Access Compliance Report

Public Rights-of-Way

| Intersection ID: 46497 | Main Street: NEWBRIDGE_RD | Cross Street: BALTRAY_RD | Location: SW |
| ADA ID: EBC9BB55E7D1 | Ramp Type: Perp | Initial Pass/Fail: Fail | Overall Compliance: No |

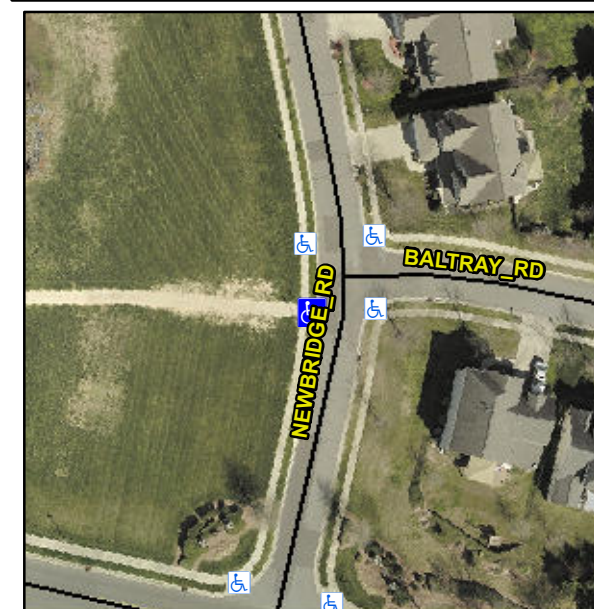
Not Found, R304.2.2

| Compliance | Description | Data | Compliance | Description | Data |
|------------|-----------------------|------|------------|-----------------------------|------|
| N/A | Ramp Length (in) | 48.0 | No | Ramp Slope (%) | 8.6 |

Remove & Replace Entire Ramp.
